Work Order ID 135255

Item Name: Quick Release Heli-Utility-Basket™ Long, HD Lid, Spacepod™/Squirrel Cheek Comp.

DART SERVICE INSTRUCTION

TO AMEND INSTALLATION INSTRUCTIONS D350-607-3 Rev.D,
 INSTALLATION INSTRUCTIONS D350-607-4 Rev. C AND
 INSTRUCTIONS FOR CONTINUED AIRWORTHINESS ICA-D350-607 REV. 6
 REF TCCA STC: SH94-14
 REF FAA STC: SR00213NY
 REF EASA STC: EASA.10016996
 REF BRAZILIAN STC: 2007S03-03/-04/-05/-06

FIGURE 1: INSTALLATION OF D4775-041 FWD STRUT

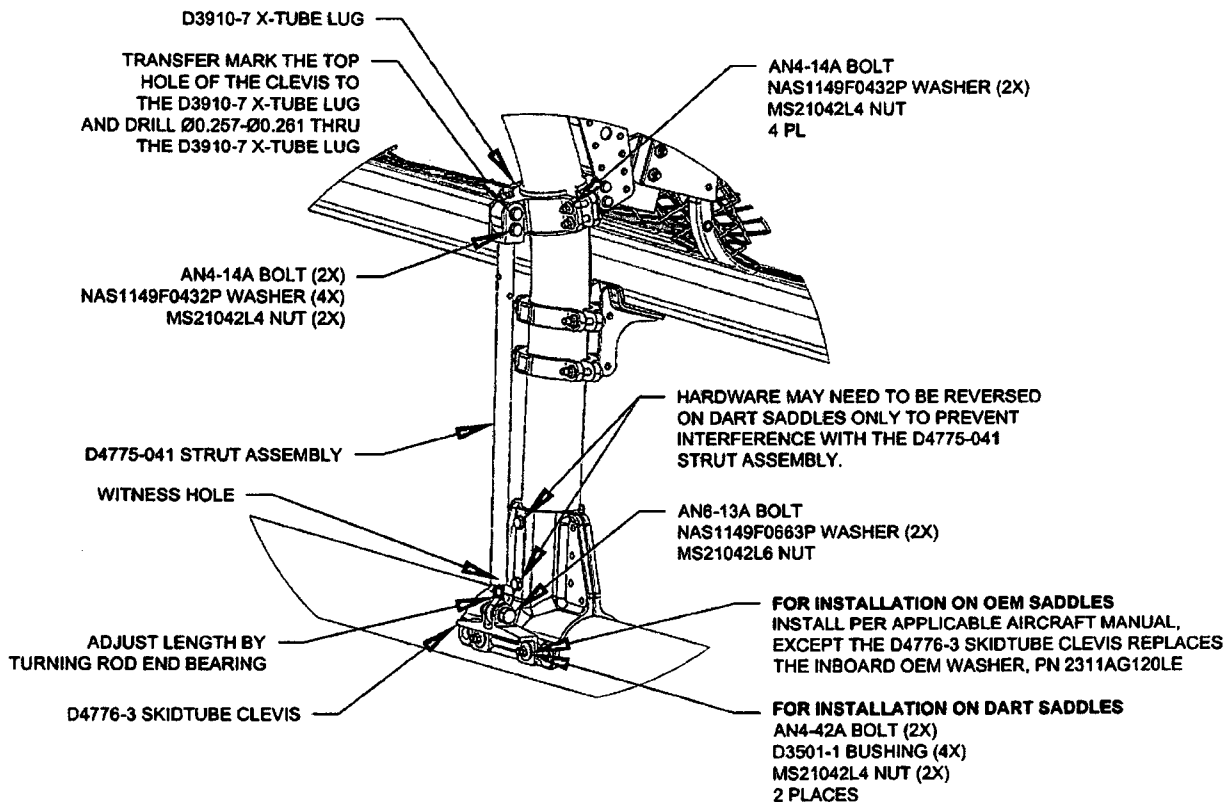
3.1 Substitute the Forward Lower D3910-5 X-Tube Lug with the D3910-7 X-Tube Lug as shown in Figure 1.

3.2 Install the forward D4775-041 Strut Assembly. Transfer mark from the upper hole on the clevis of the D4775-041 Strut Assembly to the D3910-7 X-tube Lug and drill thru the lug $\varnothing 0.257$ - $\varnothing 0.261$ as shown in Figure 1. Touch up chemical conversion coating per MIL-DTL-5541. Check the witness holes located at the bottom end of the D4775-041 Strut Assemblies to ensure that the thread from the rod end extends past the witness hole.
Torque MS21042L4/-4 nuts to 50-70 in-lbs (5.7-7.9 N-m). Torque MS21042L6/-6 nuts to 160-190 in-lbs (18.1-21.5 N-m).
